JRPP Number	2011SYW087
Application Number	DA-1210/2011
Proposed Development	Demolition of existing structures and construction of a residential flat building comprising fifty-three (53) residential units and two levels of basement car parking with vehicular access to be provided from Campbell Street and associated landscaping and service features.
Property Description	Part Lot 1 DP 1053951, Part Lot 2 1053951 93-95 Campbell Street Liverpool NSW 2170
Applicant	Gelder Architects
Land Owner	Talbus Pty Ltd
Capital Investment Value	\$11,000,000
Recommendation	Refusal

LIVERPOOL CITY COUNCIL DESIGN REVIEW PANEL ASSESSMENT REPORT

Figure 2: Proposed Streetscape Elevations to Hume Highway and Campbell Street

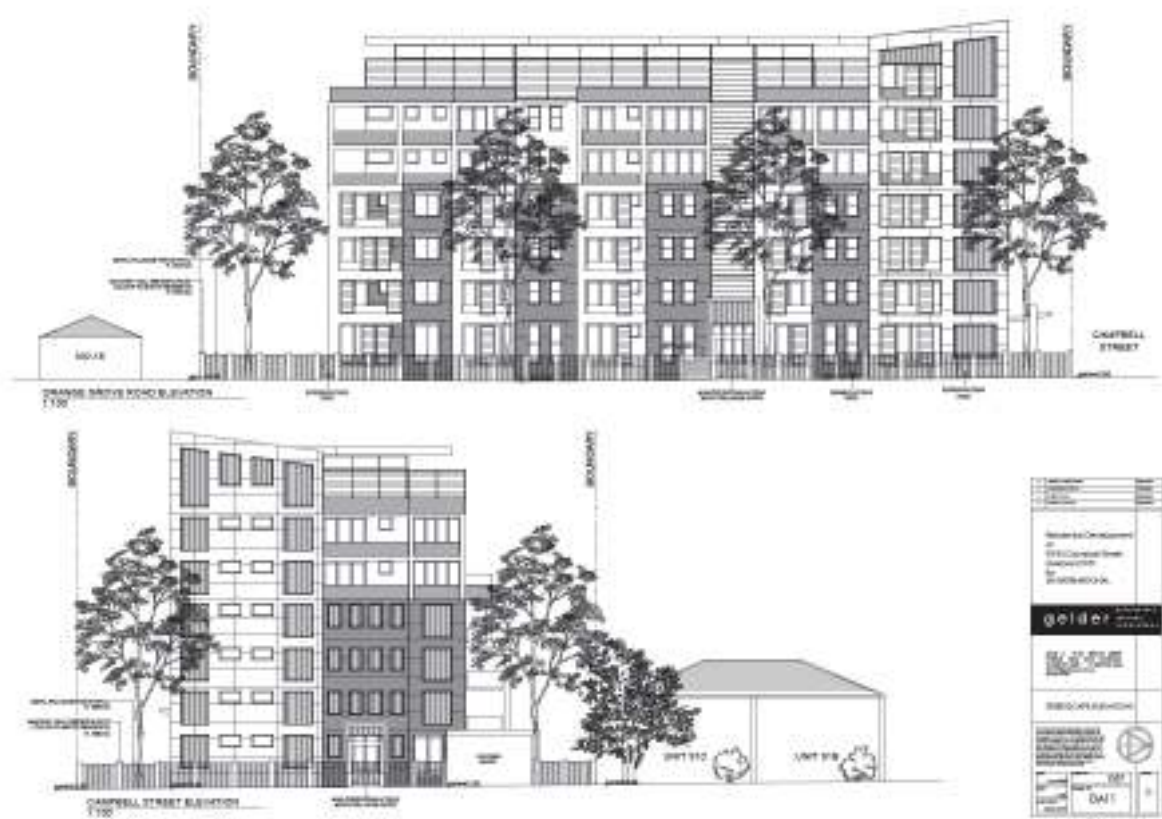
- Although proposed building forms incorporate extensive articulation, the composition of those forms does not demonstrate a satisfactory degree of cohesion, or incorporate deliberate scaling measures that would distinguish a two storey base from a light and airy penthouse level
- Proposed balcony elements lack refinement and co-ordination,
- The “corner structure” facing the street intersection displays an excessively bulky appearance

Landscape Plan

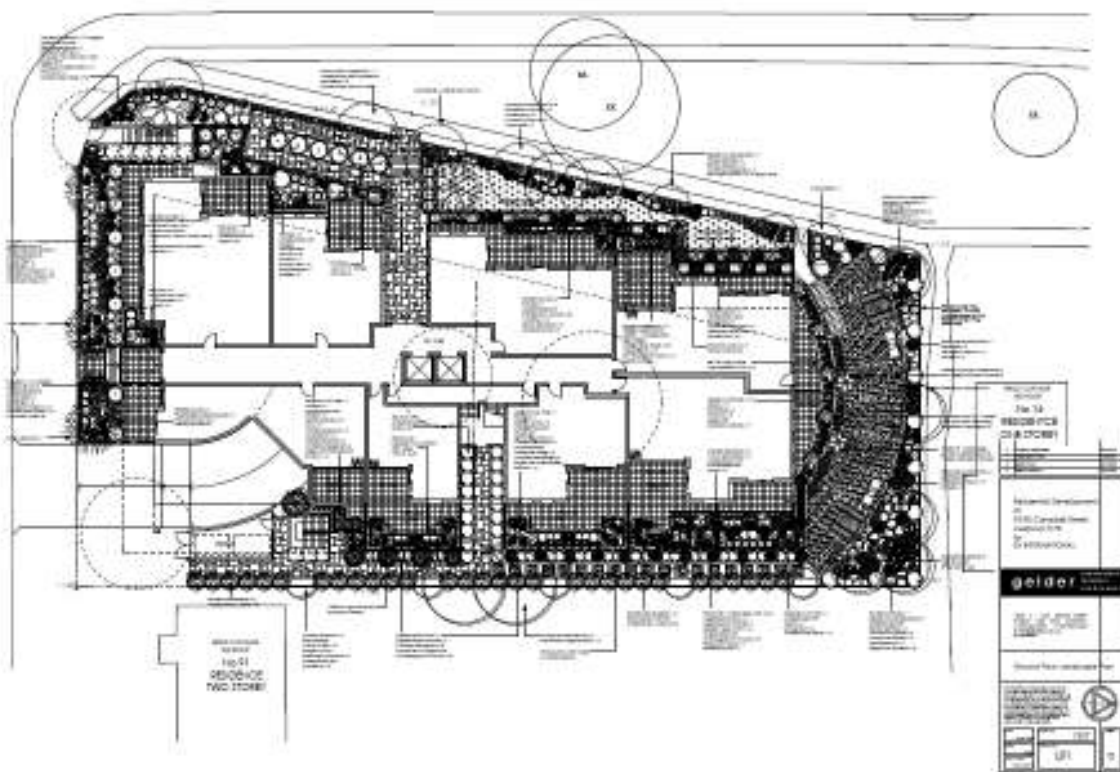
- There are inconsistencies between the architectural plans and landscape concept design.
- The architectural plans are not accompanied by furniture room layouts, particularly given the room sizes and dimensions.
- The landscape plan needs to be developed further.
- The proposal does not provide for an appropriate mix of units in relation to their sizes and number of bedrooms. This is inconsistent with the design principles within SEPP 65 and Council's DCP (DCP 2008 Part 4).
- The proposal does not have a 'designed' area for communal open space for the prospective residents.
